Unreviewed Safety Question Evaluation # B2-0022

ORIGINATING DOCUMENT: CN-1980

ATTACHMENT TO USGE 92-0022  
ORIGINATING DOCUMENT LCN-4777 1980

## UFSAR MARKUPS

FIGURE 12.3.1-25 REVISION

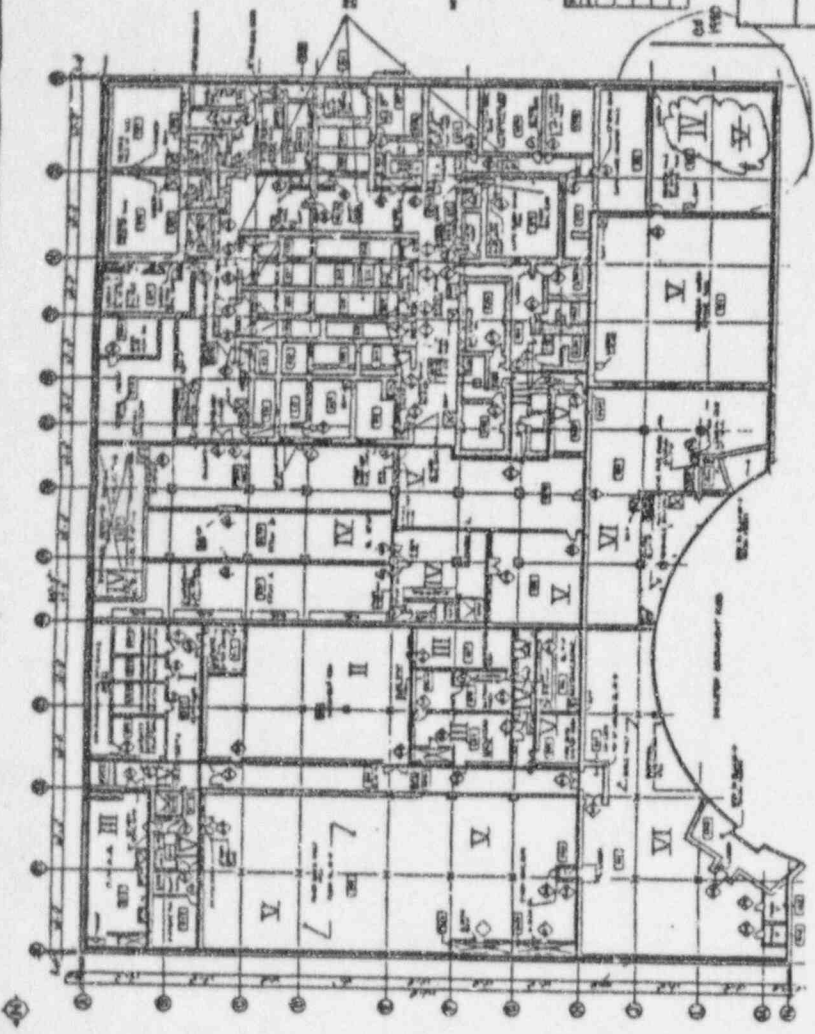
UFSAR Figure Reference	Area	Dose Rate (R/Hr)			
		Time after accident			
		1 hr	1 day	1 wk	1 month
12.3.1-36	Post-accident sample station	.75	$4.5 \times 10^{-2}$	$1.1 \times 10^{-2}$	$6 \times 10^{-4}$
12.3.1-27	Health Physics counting room	$6 \times 10^{-3}$	$3.6 \times 10^{-4}$	$9 \times 10^{-5}$	$4.8 \times 10^{-6}$
12.3.1-27	Radwaste counting room	$3.1 \times 10^{-2}$	$1.8 \times 10^{-3}$	$4.6 \times 10^{-4}$	$2.4 \times 10^{-5}$
12.3.1-28	Plant vent radiation monitor	4.74	.28	$7.1 \times 10^{-3}$	$3.8 \times 10^{-3}$
12.3.1-25	Auxiliary shut-down panel	$8 \times 10^{-4}$	$4.8 \times 10^{-5}$	$1.2 \times 10^{-5}$	$6.4 \times 10^{-7}$

FIGURE 19.B-2

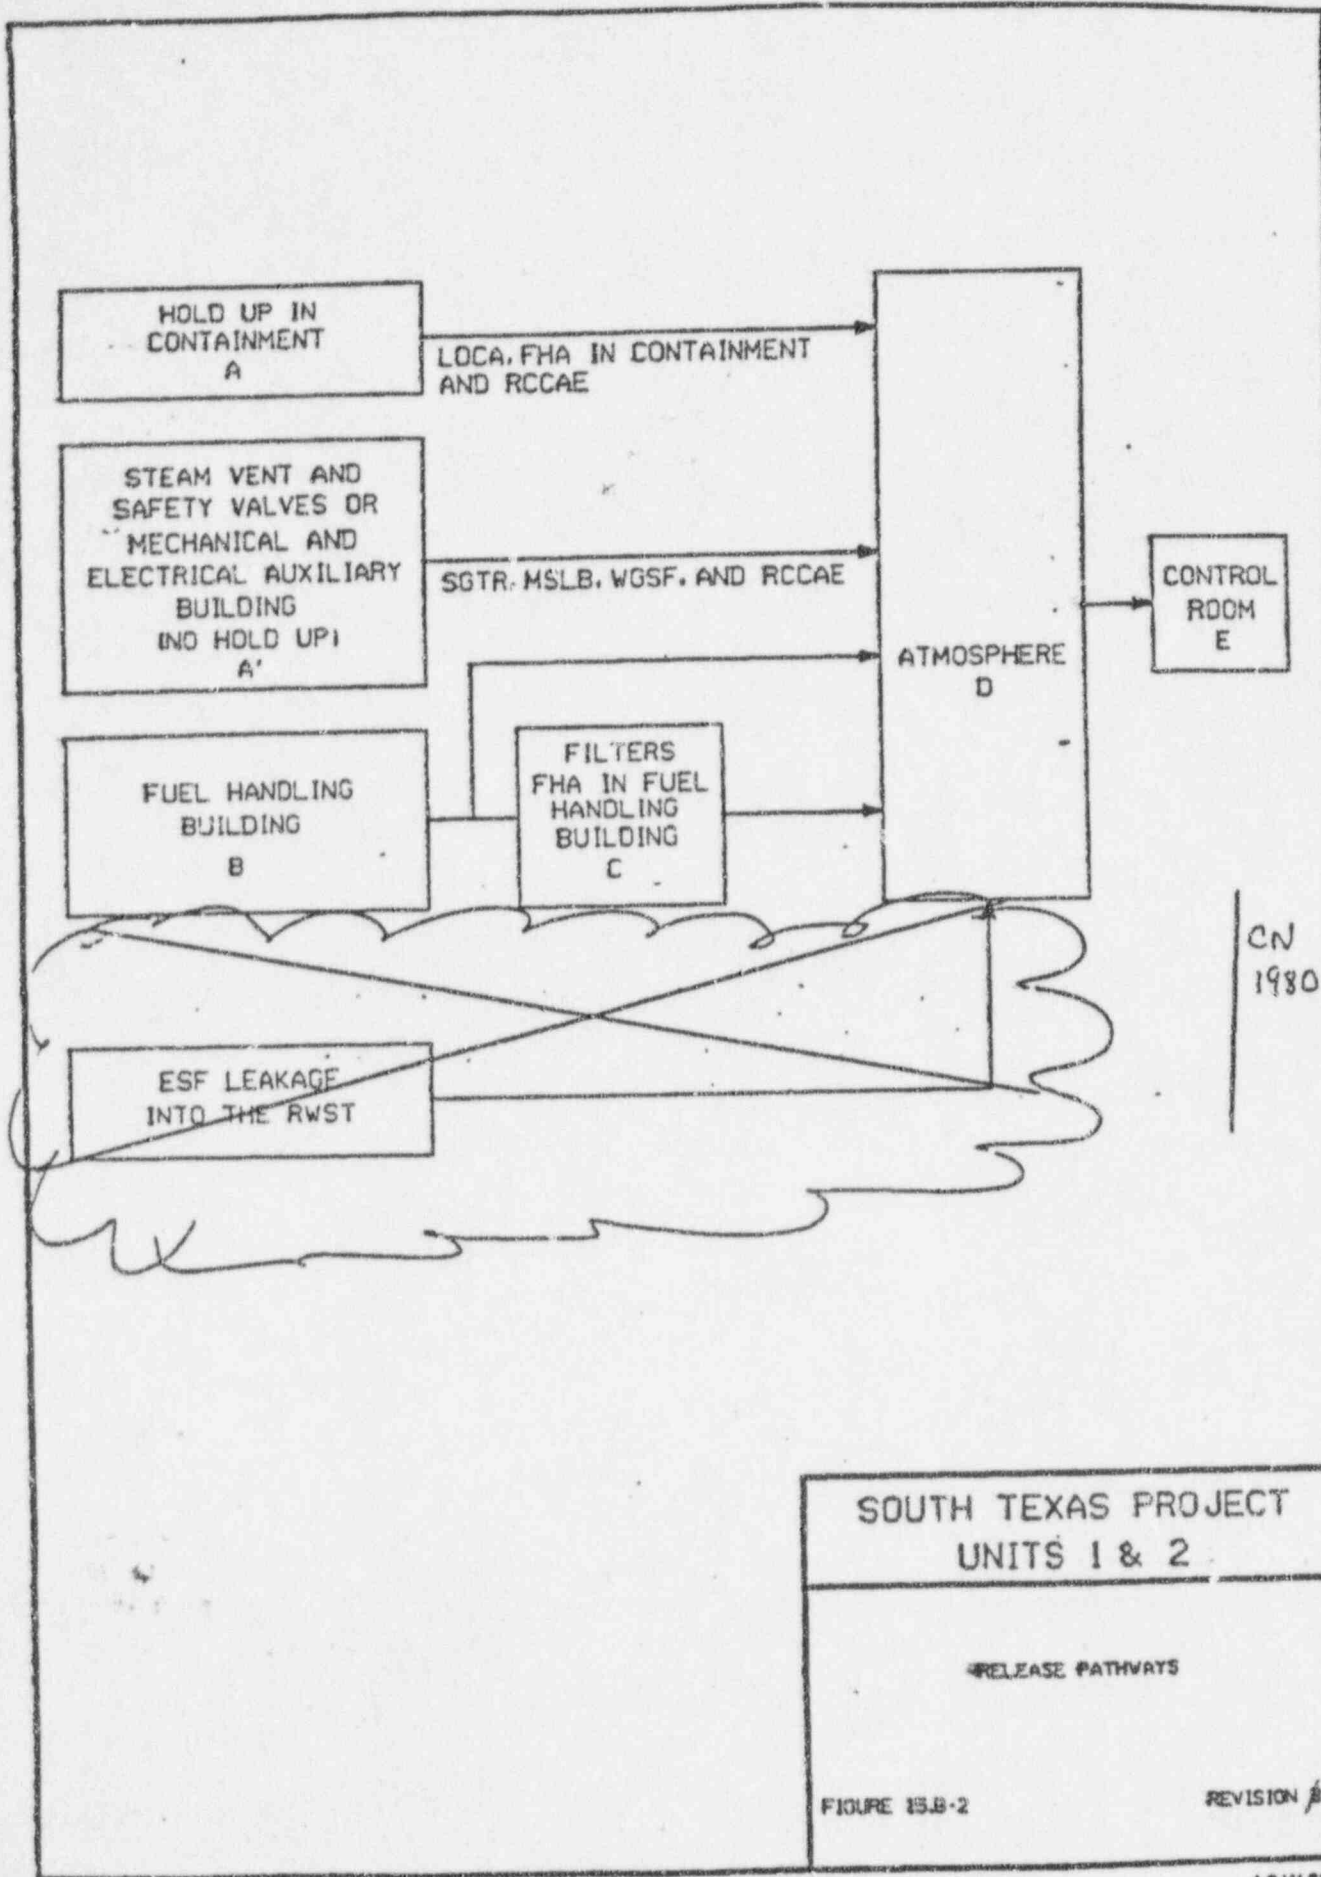
~~The release of radioactivity to the environment due to assumed ESF leakages into the Refueling Water Storage Tank (RWST) is immediately dispersed into the environment and is calculated using Equation 15.B.2-5. However, no credit is taken for the holdup time of fission products in the atmosphere of the Mechanical Auxiliary Building (MAB).~~
